17-083ARB-INF– YODER RESIDENCE

Architectural Review Board

Informal Review of a proposed building addition.

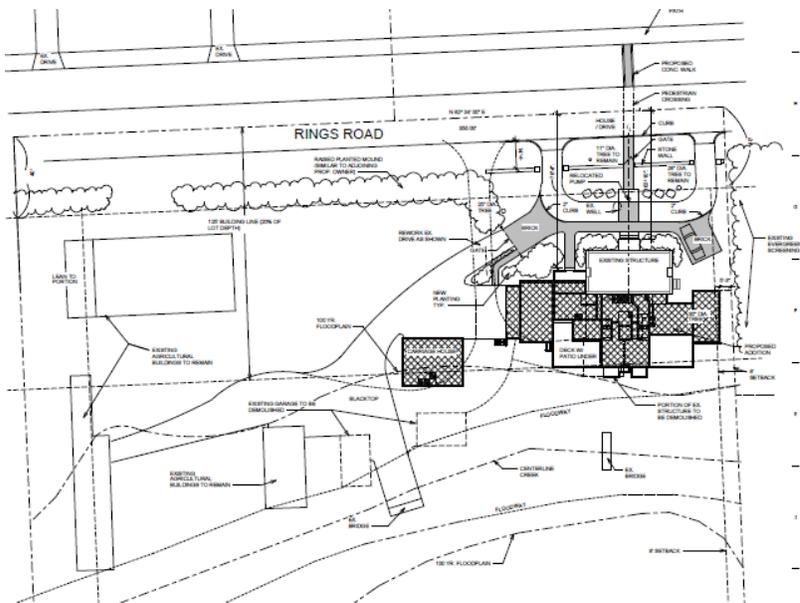
Staff: While the wing additions are one-story, the two story addition is at the same height of the existing structure and is three times the size of the remaining historic building. As the residence exists today, the additions that have been added over time have been one-story in height and subordinate to the historically significant residence.

Consultant: The consultant states the proposed east addition with the master bedroom is more sympathetic than the west addition containing the multi-purpose room and garage. The east addition is set back from the historic building and does not appear to engulf it in plan or elevation; its height is also nicely scaled down from that of the historic structure so it does not overpower it.

The proposed west addition, on the other hand, is almost the same width and height as the historic core structure in elevation and almost twice the size in plan. It overpowers the historic structure. There is no "breathing room" between the historic building and the new; the new addition almost completely engulfs the old. This will be apparent along the front and side of the building exposed to the public street. Preferably, any large addition (such as the three-car garage) should be to the rear of the property where it is not visible from the street and will not have a significant visual impact on the historic structure. Any addition should set back from

the front of the main house, possibly along the 80' building line, so it does not compete with the original structure.

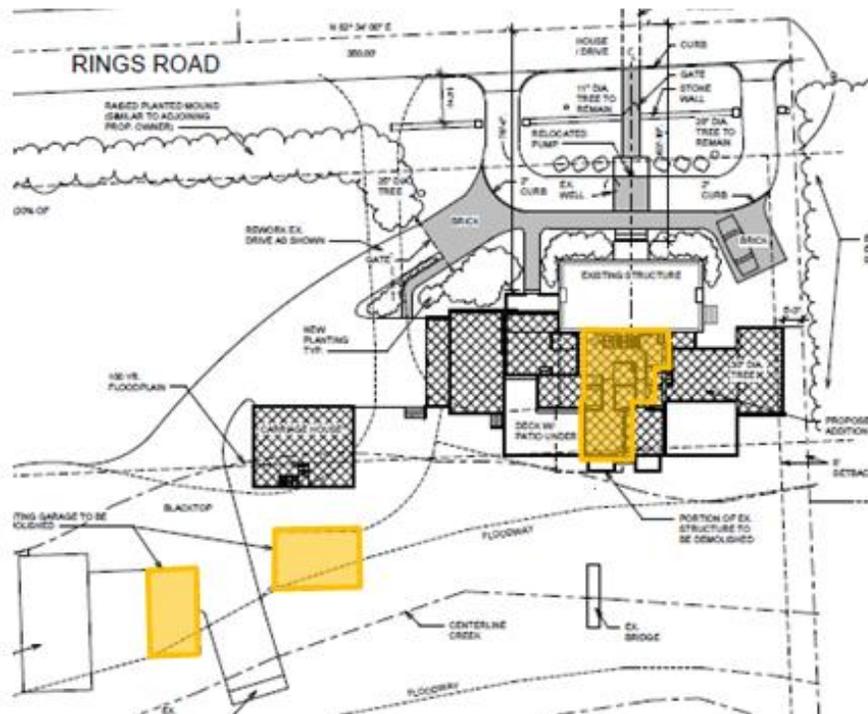
The applicant is proposing to demolish a detached accessory structure (garage) on the site and the additions made over time to the existing structure and. The applicant has submitted a separate application to be reviewed by the Architectural Review Board at a future meeting. The portions to be demolished are highlighted in yellow on the plan below.

Staff: The overall property is part of the National Historic Registry under the Washington Township Multiple Resource Area designation, which includes all of the structures on site. The addition appears to have historic character with attributes of the time period when constructed.

Consultant: The brick extensions to the main house may be original or very early additions to the building. As such, they may contribute to the historic character of the National-Register listed building. It is recommend to avoid removing historic material if at all possible, especially if it is in good condition. (Exceptions can be made for deteriorating materials or structures that pose a health and safety issue,

but documentation must be provided.) It also appears that several windows in the existing historic core building will need to be removed, modified, or enclosed. These windows are character-defining features of the National-Register eligible property and should be maintained if possible.
